REGIONAL REVIEW NOTICE

ARC REVIEW CODE: R1602161

Name of Proposal: Civic Center Mixed-Use

SUBJECT: **Transportation Division Review of DRI # 2542**

DRI SITE PLAN

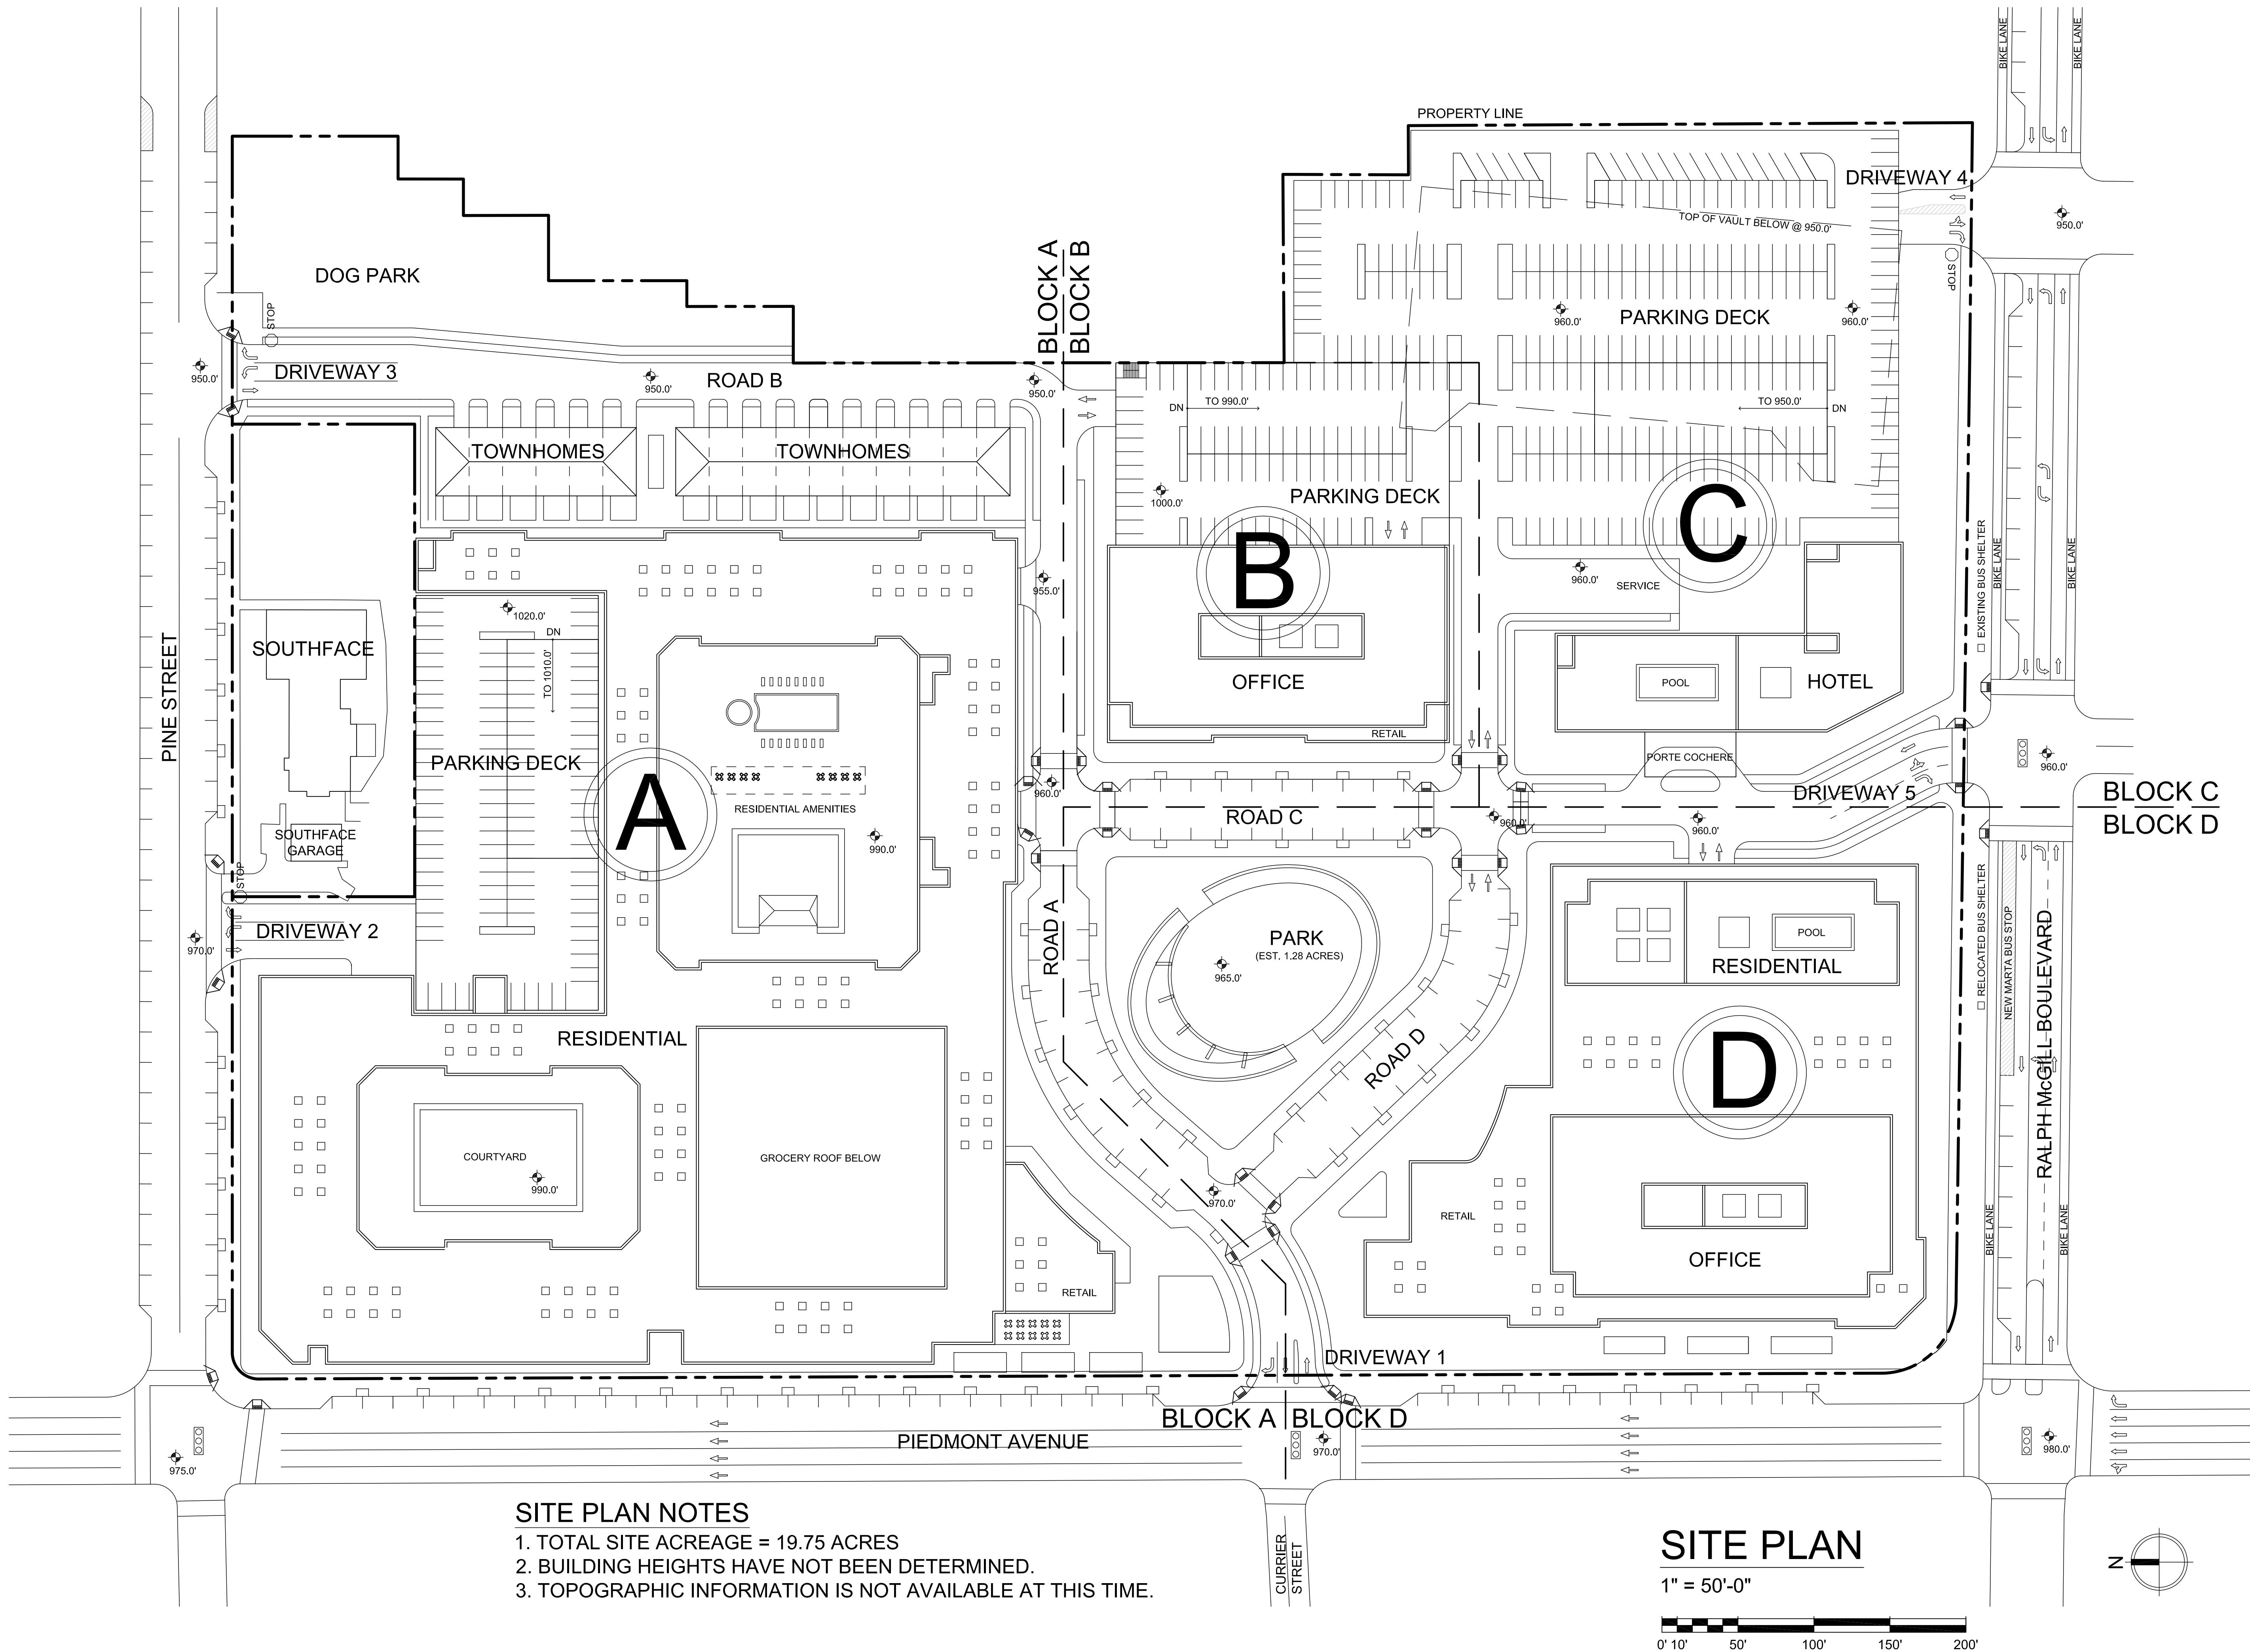
The current development plan proposes a total of approximately 5,000 parking spaces, primarily concentrated in two parking structures. In keeping with the goals of ARC's LCI program, the developer and City staff should work together to reduce the overall parking totals on the site to reinforce and encourage the use of alternative transportation modes such as transit, bicycling and walking. Use of these modes is already present in the area, and parking reductions can be accomplished, at least in part, through shared parking strategies.

The team should conduct the shared parking analysis to reduce the 5,011 parking spaces. The ratios of 1.5 spaces per 1 bedroom unit and 2.5 per 2 bedroom unit are high for the area and the manner in which a development should fit in here. The increased use of car-sharing should also influence a decrease in retail and office parking. Bicycle parking facilities, including but not limited to fix-it-stands, lockers, showers (for office employees) should be added around the site buildings and/or parking decks to provide a convenient destination for bicyclists visiting the site. Lastly, the parking deck to be located south of Southface should be minimized in height so as not to affect the solar panels Southface harnesses much of its energy from.
